Appendix 'D' - Recommended First Reading Alterations to the Precinct 'G' Secondary Plan

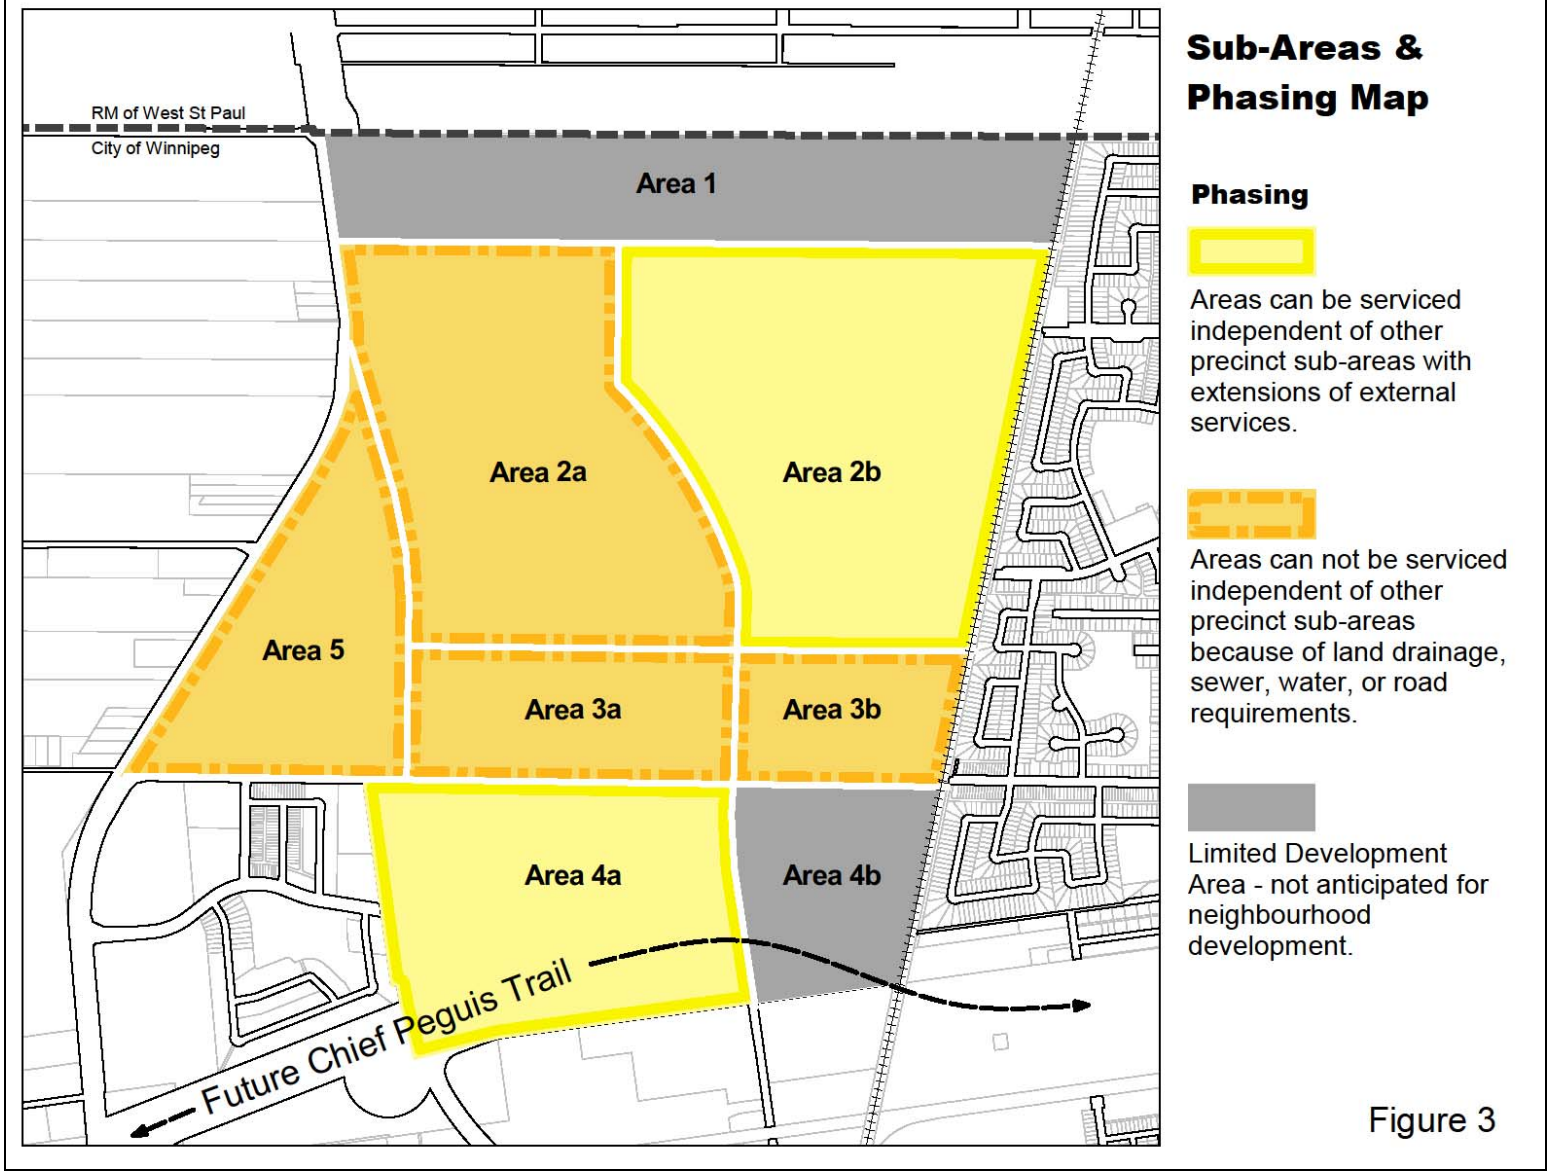
36	Delete the following pre-amble to section *6.1 Staging and Phasing*: *"The policies of this section serve to ensure that the orderly development of the Precinct can be accommodated by appropriate infrastructure. The phasing plan for Precinct G is illustrated in Figure 3. Development phasing within the Precinct is primarily based on infrastructure requirements (including roads, water, wastewater, and land drainage) on a sub-area basis. The Plan assumes that a majority of development will take place over a 25-year time horizon.* *Phasing for development of each Sub-Area within the Precinct is subject to the following constraints as outlined in Figure 7:* • *Sub-area 2a, 4a, and 4b, identified as yellow in Figure 7, can be serviced independent of other Precinct sub-areas with minor extension of services.* • *Sub-areas 2b, 3a, 3b, and 5 identified as magenta in Figure 7, cannot be serviced independent of other Precinct sub-areas because of land drainage, sewer, or water servicing constraints.* • *A majority of sub-area 1a, identified as grey in Figure 7, is currently used as a City of Winnipeg snow dump. There are no plans to cease operations of the snow dump in the foreseeable future.* • *Sub-area 1b, identified as green in Figure 7, is a closed landfill and may be considered in the future as a passive park space.* • *The narrow strip of land north of sub-areas 1a and 1b cannot be serviced independent of other Precinct sub-areas because of land drainage, sewer, water and road constraints."* And replace with the following: *The policies of this section serve to ensure that the orderly development of the Precinct can be accommodated by appropriate infrastructure. The phasing plan for Precinct G is illustrated in* ***Figure 3 (Sub-Areas and Phasing Map).*** *Development phasing within the Precinct is primarily based on infrastructure requirements (including roads, water, wastewater, and land drainage) on a sub-area basis. The Plan assumes that a majority of development will take place over a 25-year time horizon.* *Phasing for development of each Sub-Area within the Precinct is subject to the following constraints as outlined in* ***Figure 3 (Sub-Areas and Phasing Map)****.* • *Sub-areas 2b and 4a identified as yellow in Figure 3 can be serviced independent of other Precinct sub-areas with minor extension of services. More specifically, sub-area 2b can be serviced to accommodate single-family dwellings. However, the Servicing Brief has not demonstrated that multi-family development can be adequately serviced by the water infrastructure in sub-area 2b without additional connections to the south or southwest. Further review is required to confirm the extent of multi-family development in sub-area 2b prior to connections to the south. Per policy 3.4.5, no neighbourhood development will be permitted in the southern portion of sub-area 4a until the alignment of the Future Chief Peguis Trail right-of-way has been determined and approved by Council.*

• *Sub-area 2a, identified as orange in Figure 3, cannot be serviced independent of other Precinct sub-areas because of land drainage, sewer, or water.* • *Sub-area 3a, identified as orange in Figure 3, cannot be serviced independent of other Precinct sub-areas because of land drainage.* • *Sub-areas 5 and 3b, identified as orange in Figure 3, cannot be fully serviced independent of other Precinct sub-areas.* • *Sub-areas 1 and 4b identified as grey in Figure 3, have limited development potential. Area 1 is predominantly comprised of an operational snow dump with no plans to cease operations in the foreseeable future and a closed landfill. The closed landfill may be considered in the future as a passive park space. The majority of Area 4b is required for long-term plans to develop a support-type land use related to the North End Sewage Treatment Plant and some of the lands may be required for the Future Chief Peguis Trail.*

37	Delete the following policy under section *6.1 Staging and Phasing*: *6.1.1* "*Development of the Planning area will generally be phased in accordance with Figure 7 and the following:* • *Development within sub-areas 2a, 4a, and 4b, identified as yellow in Figure 7, may be developed independently of development in other areas.* • *Development within sub-areas 2b, 3a, 3b, and 5, identified as magenta in Figure 7, cannot be developed until land drainage, sewer, and/or water servicing can be extended from adjacent sub-areas."* And replace with the following: *6.1.1 Development of the Planning area will be phased in accordance with Figure 3: Sub-Areas and Phasing Map and the following:* *a) Development within sub-areas 2b and 4a identified as yellow in Figure 3 may be developed in advance of development in other areas.* *i) Per policy 3.4.5, no neighbourhood development will be permitted in the southern portion of sub-area 4a until the alignment of the Future Chief Peguis Trail right-of-way has been determined and approved by Council.* *b) Development within sub-areas 2a, 3a, 3b, and 5 identified as orange in Figure 3 will not be developed until land drainage, sewer, and/or water servicing can be extended from adjacent sub-areas.*

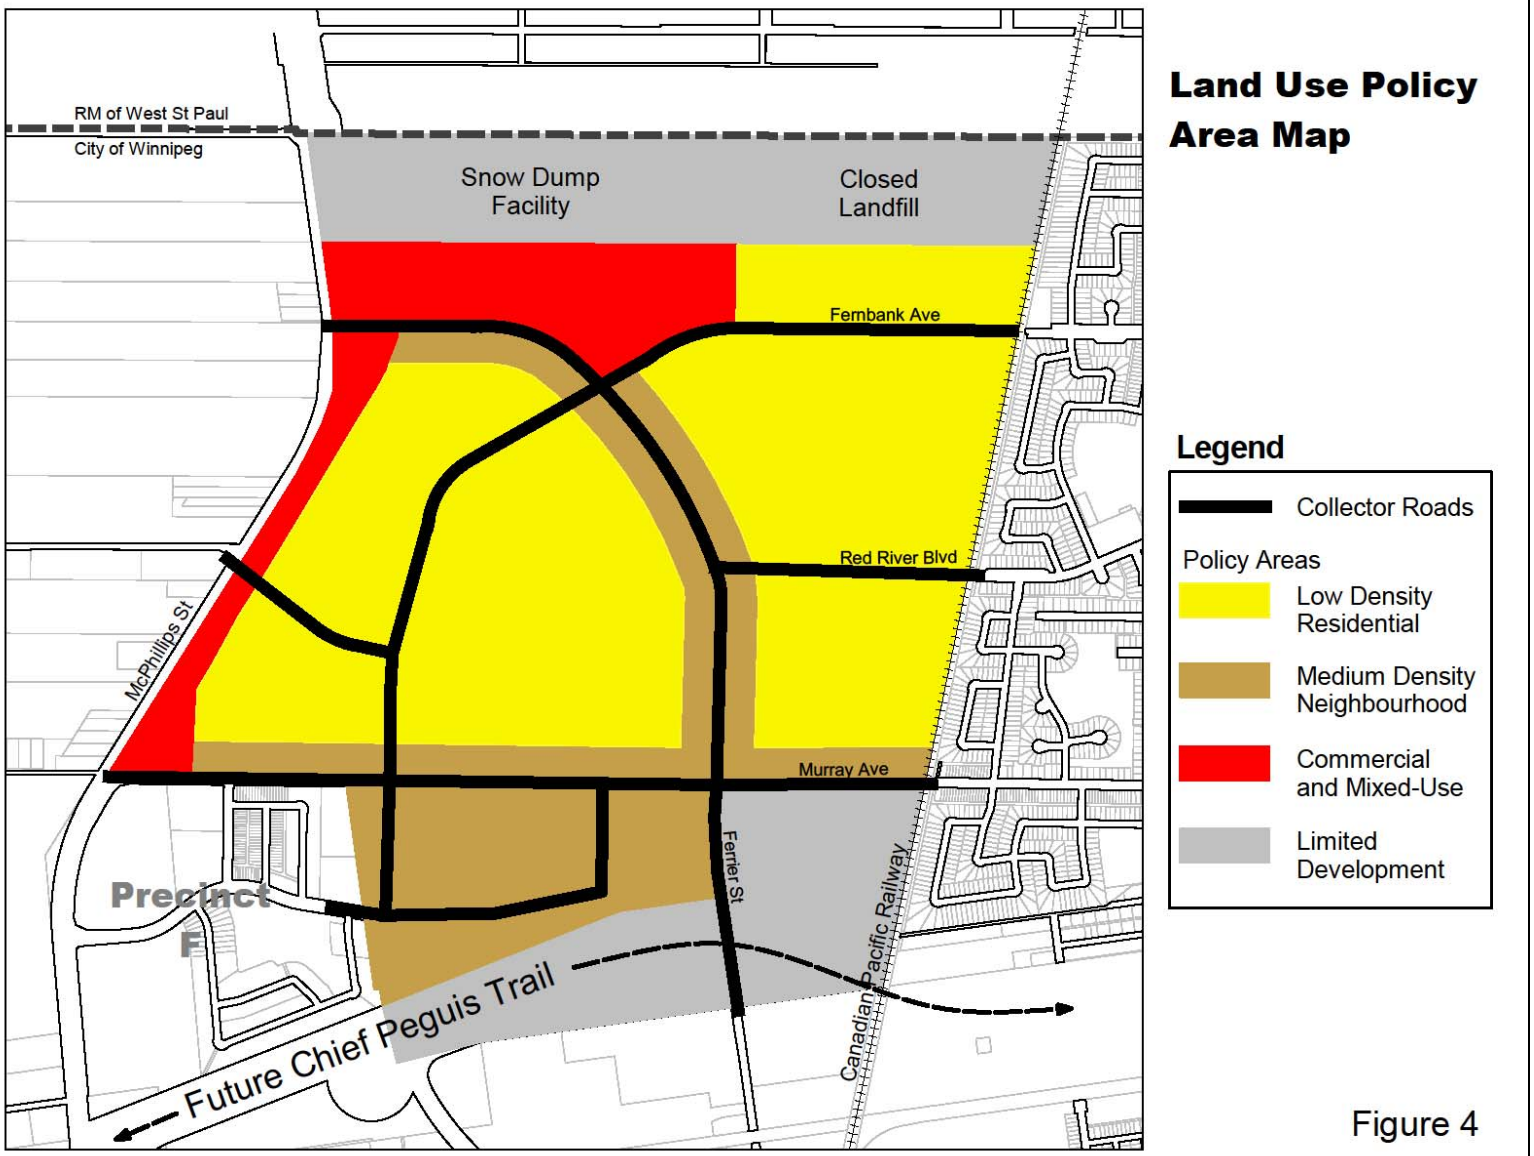
42	Delete *Figure 4 "Land Use Policy Map"* and replace with the following:

Figure 5

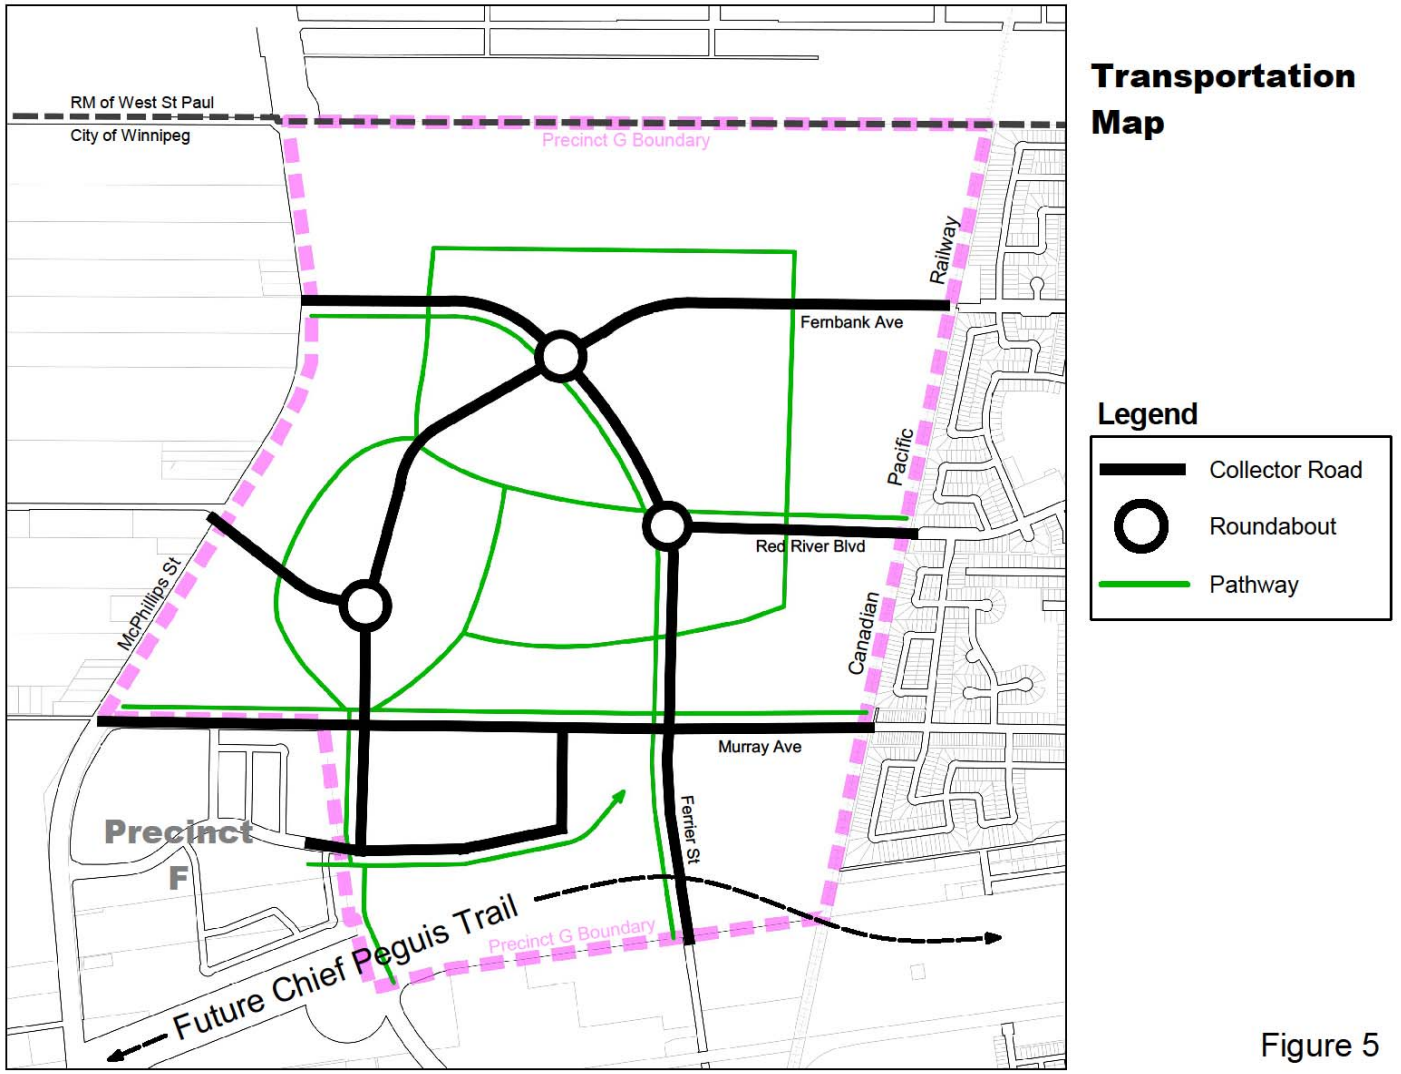
43	Delete Figure 5 *"Transportation Map"* and replace with the following:
44	Delete Figure 7 "Phasing Map".
